Re: Minor Project Refinement No. 3 for the Round Mountain 500 kV Dynamic Reactive Support Project

Round Mountain 500 kilovolt (kV) Dynamic Reactive Support Fern Road Substation Project CPUC Minor Project Refinement Form

Report No.: 3

MPR-3
Figure 1 Work Areas

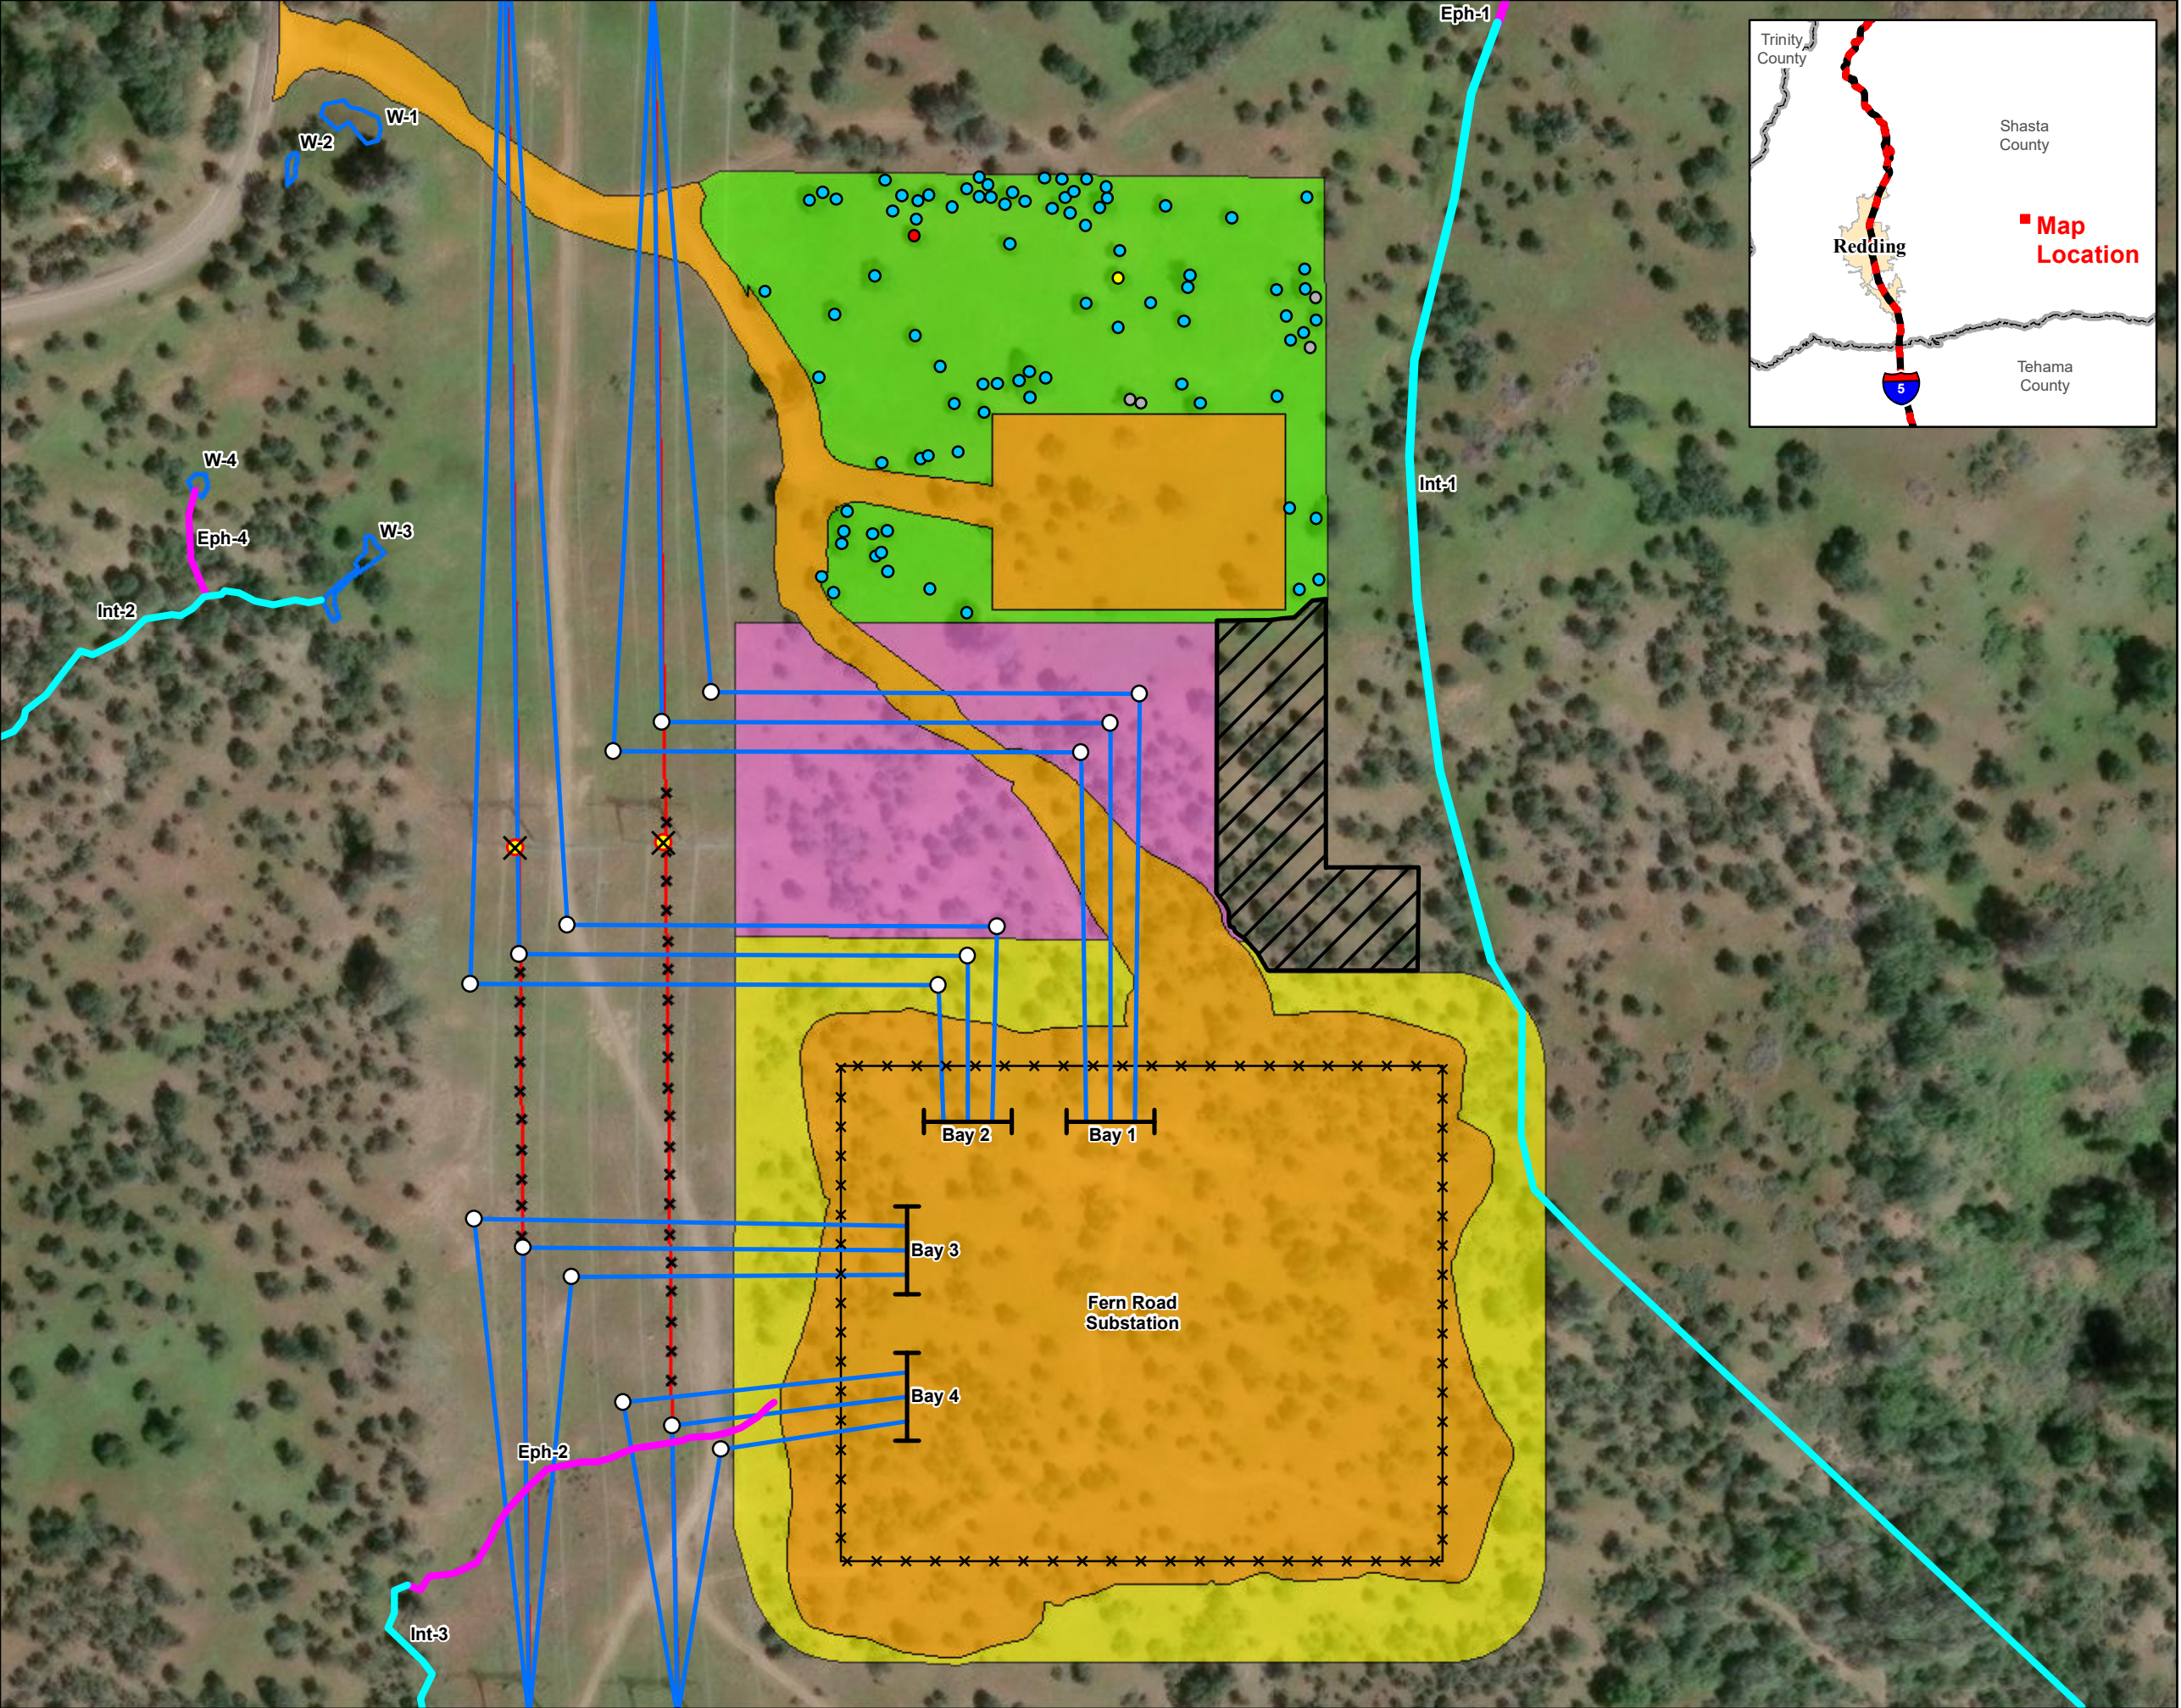
LSPGC is requesting approval of MPR-3 for the use of three temporary work areas for the Round Mountain 500 kilovolt (kV) Dynamic Reactive Support Project (Fern Road Substation or Project), as described below and shown in **Attachment B, MPR-3 Figure**.

- **Expanded Staging Area (4.3 Acres):** This temporary area shown in green in **Attachment B** is proposed for use as an extension to the existing staging area approved

- **Materials Storage within MPR-2 Work Area (3.1 Acres):** This area shown in pink in **Attachment B** has been previously cleared of trees and large shrubs in accordance with the approved scope of MPR-2. MPR-3 is proposing an additional use of this area for laydown and overflow materials storage such as steel beams, anchor bolt cages, and other components or equipment as needed. There is no grading or gravel placement proposed within this area. As discussed in MPR-2, this area will be permanently maintained and kept clear of trees or tall shrubbery.

- **Materials Storage – No Tree Removal (1.1 Acres):** This temporary area shown in black hatching in **Attachment B** has not been previously disturbed by the Project. Existing vegetation and trees would remain in place and no ground disturbance or grading is anticipated. This area would be utilized as overflow materials storage for substation components or other materials within the existing clearings as needed.
